INNER WEST

DEVELOPMENT ASSESSMENT REPORT

Application No.	DA/2023/0358
Address	6 Clifton Street BALMAIN EAST NSW 2041
Proposal	Part demolition, and alterations and additions to existing dwelling house to allow for a part second floor addition with roof deck
Date of Lodgement	18 May 2023
Applicant	Raddatz Kueber Pty Ltd
Owner	Mrs Wendy A Hardy Mr Simon J Hardy
Number of Submissions	Initial: 1
Value of works	\$624,075.00
Reason for determination at Planning Panel	Section 4.6 variation exceeds 10%
Main Issues	Overdevelopment, Impact to Heritage Conservation Area
Recommendation	Refusal
Attachment A	Reasons for refusal
Attachment B	Recommended conditions of consent
Attachment C	Plans of proposed development
Attachment D	Section 4.6 Exception to Development Standards
Attachment E	Statement of Heritage Significance

View of No. 2-4 Clifton Street and No. 6 Clifton Street

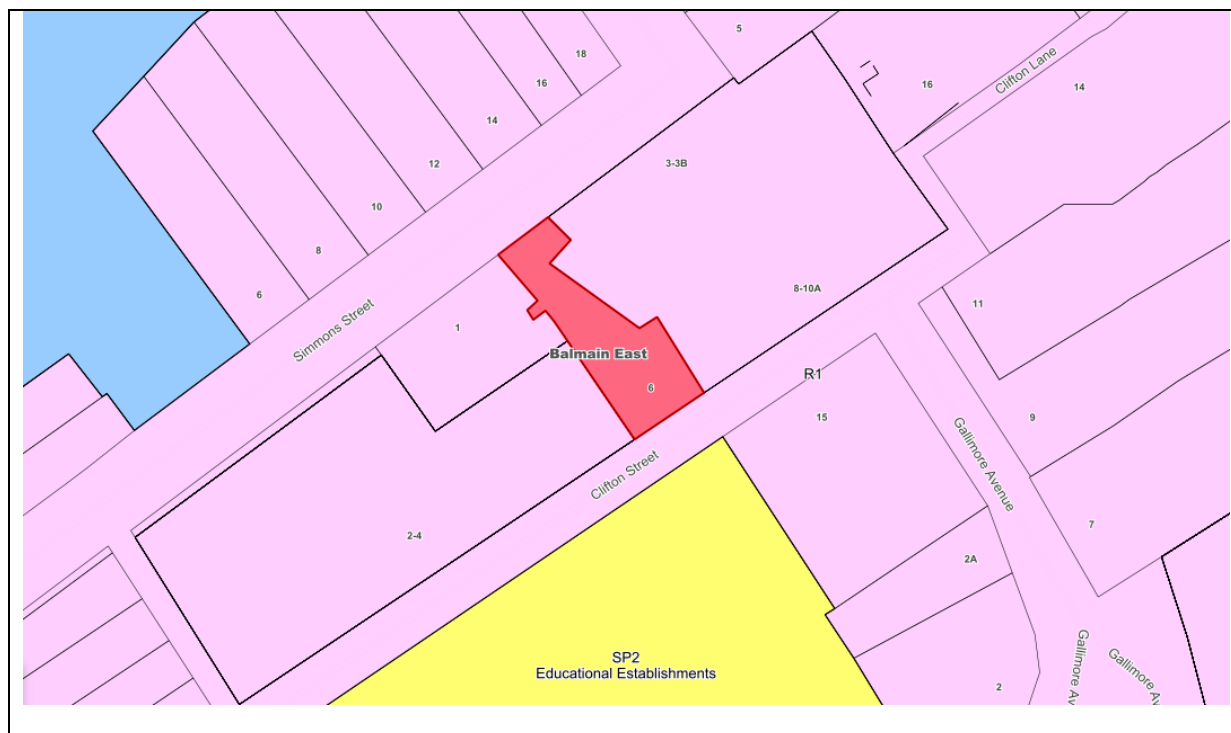
Comment: The proposed three storey form as previously mentioned in this report is considered to have unacceptable streetscape impacts to the Heritage Conservation Area and is considered to be incompatible with the existing pattern of development of the area.

Comment: The development will result in an adverse streetscape and heritage impacts to the conservation area.

Comment: For the reasons mentioned elsewhere in this Report, the proposal will result in a pattern of development that will compromise the existing streetscape and character of the heritage conservation area.

Number: AD-03 201
 Drawing: PROPOSED - ELEVATION - EAST
 Project: Hack Residence
 Site Address: 6 Cliff St (Opposite Lot: N891, 2251)
 Date of Issue:

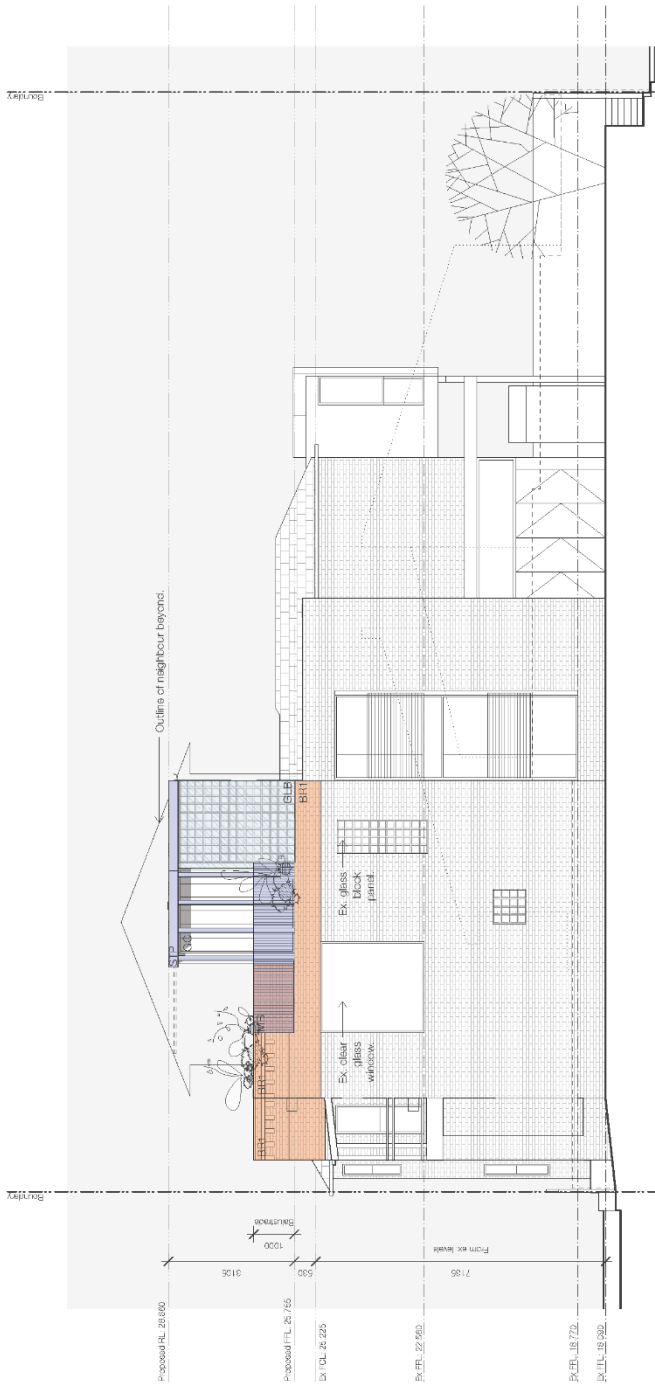
Comment: The proposed third level has a floor to ceiling of 2700mm and therefore is not minimised, however, as it is located at the front of the property, there are no adverse bulk and scale impacts to the adjoining properties when viewed from private open spaces.

Comment: The proposed third level has a floor to ceiling height of 2700mm and therefore minimal floor to ceiling heights have not been employed.
